PCI-SIG ENGINEERING CHANGE NOTICE

TITLE:	Downstream Port Containment related Enhancements
DATE:	Final version – Jan 28, 2019
AFFECTED DOCUMENT:	PCI Firmware Specification, Rev. 3.2
SPONSOR:	Mahesh Natu, Rob Gough (Intel Corporation)

DPC event handling when firmware maintains control of AER and DPC

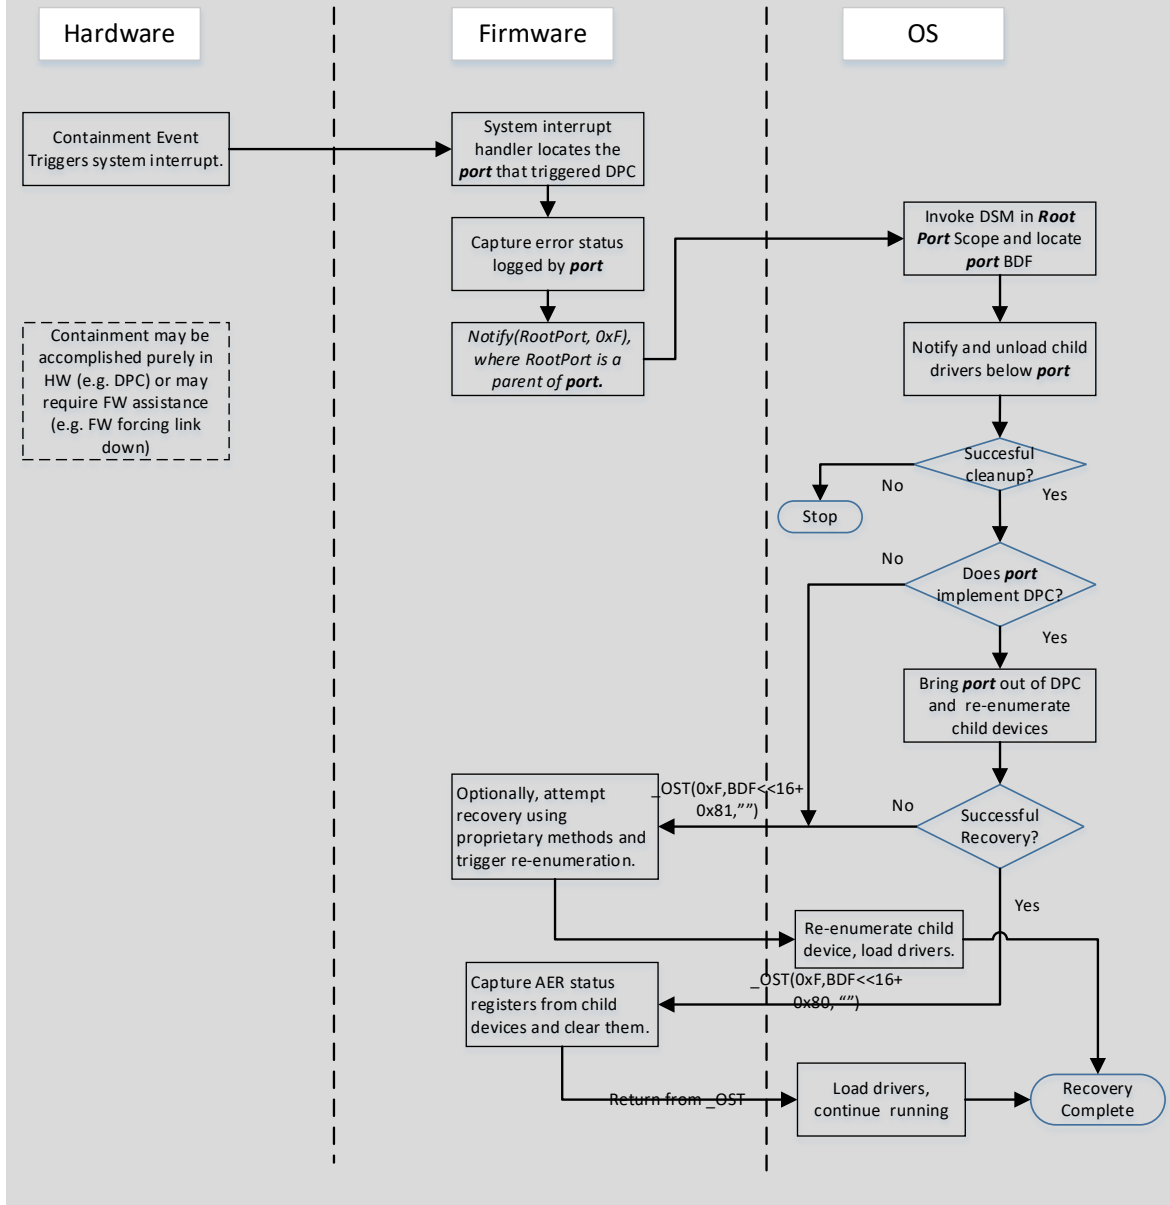
IMPLEMENTATION NOTE
